G.O., 19th July 1895, No. 1796 W.

TYPE DESIGN OF QUARTERS FOR CIVIL HOSPITAL ASSISTANTS.

GOVERNMENT OF MADRAS.
PUBLIC WORKS DEPARTMENT.

STANDARD PLAN OF QUARTERS FOR CIVIL HOSPITAL ASSISTANTS

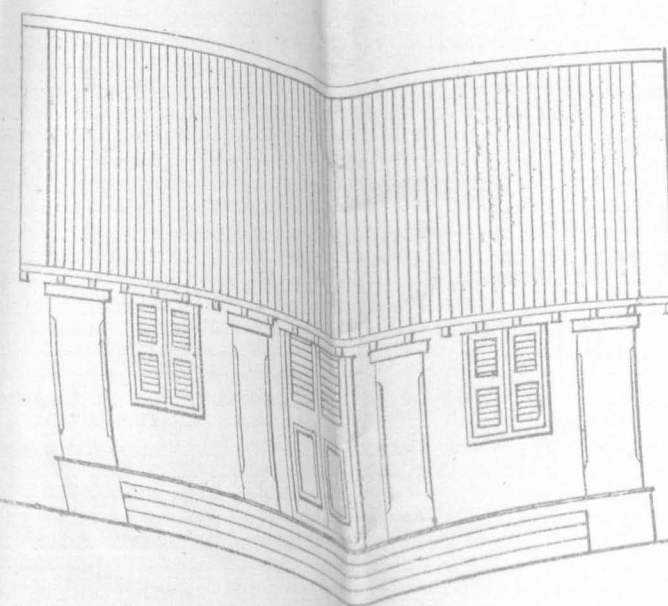
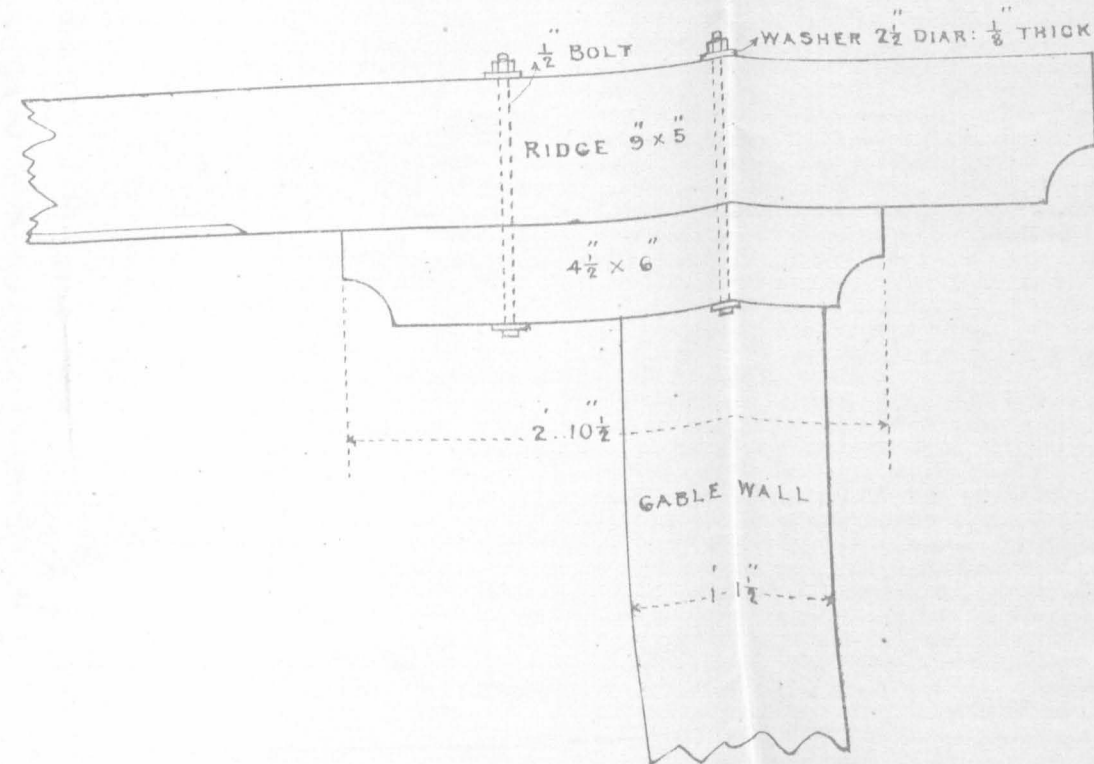
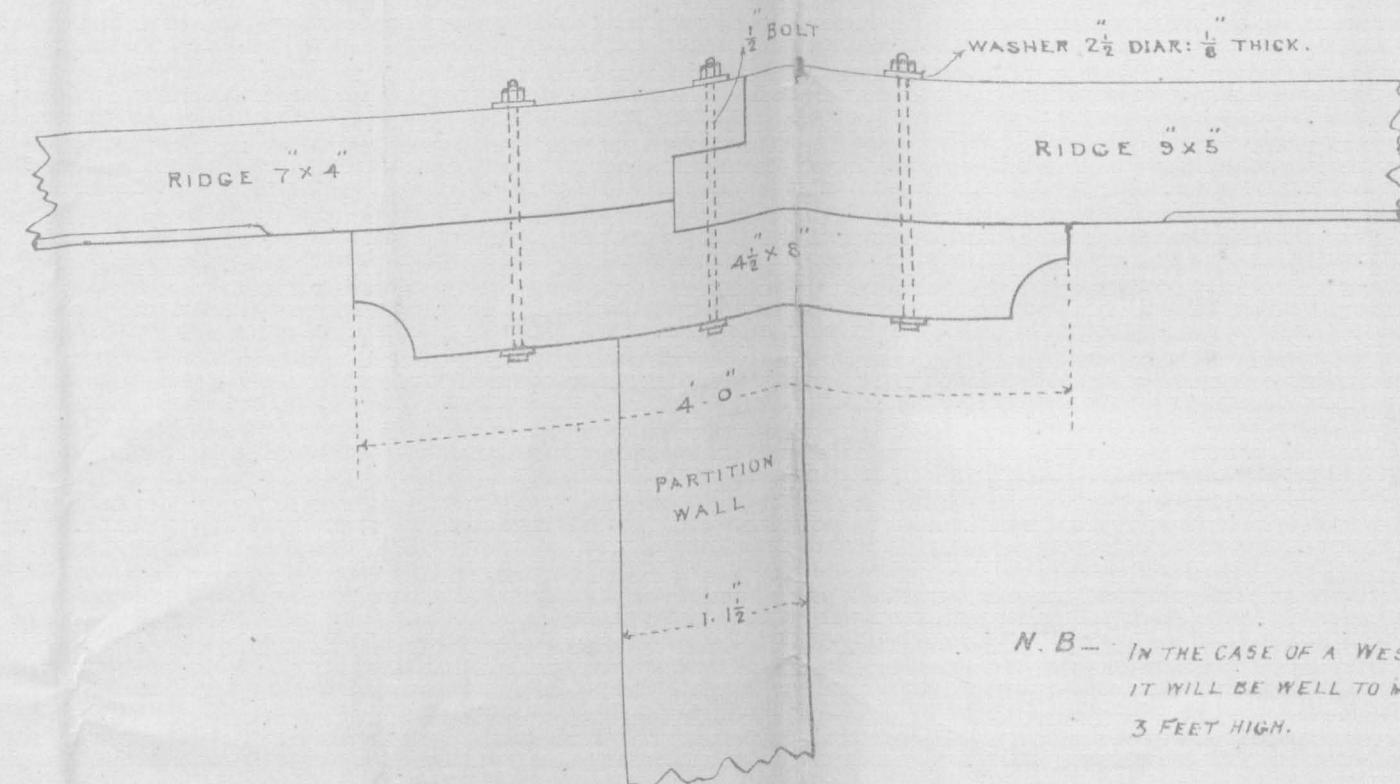
ABSTRACT.—Stating that he approves of the design of the quarters for the hospital assistants attached to the Madras Penitentiary, but that the measurements of the rooms should correspond with those prescribed in G.O., dated 14th November 1894, No. 865, Public.

2. In regard to the site for quarters for the hospital assistants attached to the General Hospital, it is observed that in paragraph 3 of his No. 636 of the 3rd December last, the Surgeon-General strongly recommends that the hospital assistants' quarters should be built near Adam's Park and the site at first proposed for them be utilized for quarters for the head steward, who should, in the interests of the institution, live near the hospital.

3. The Government desires to impress on the Surgeon-General and the Consulting Architect that the open piece of ground they propose to cut up is a very valuable site, and that if devoted to building purposes it is essential that the greatest possible use should be made of it,—in other words, that as little of the available space as possible should be taken up by the quarters to be erected on it. It is possible there may be other subordinates of the hospital whose duties require their residence in the vicinity of that institution and for whom it is desirable that quarters should be provided. The Surgeon-General will reconsider his proposals and submit a complete scheme.

4. From the site plan furnished by the Consulting Architect it appears that he proposed three detached quarters for hospital assistants with a broad space between their northern limits and the private houses, &c., already existing. This would result in waste of valuable land, and the open space would inevitably become a latrine and dust-heap. In any plan for utilizing the site in question provision should be made for including its whole width unless the municipality are willing to make and maintain in proper order a lane between the quarters and the private houses to the north of them. Such a lane would be useful for conservancy purposes. The Consulting Architect will communicate with the municipal authorities on the point before preparing any further plans.

5. It seems to Government that it would be possible to throw all the quarters required into a single block of three or four stories of an elevation suited to the position. The area of site should be economised as far as possible. In this connection it is observed that the frontage allowed for the hospital assistants' quarters on the site plan appears to be excessive; it might apparently be reduced to 18 feet.

The standard plan for quarters for civil hospital assistants and the estimate of cost are approved.
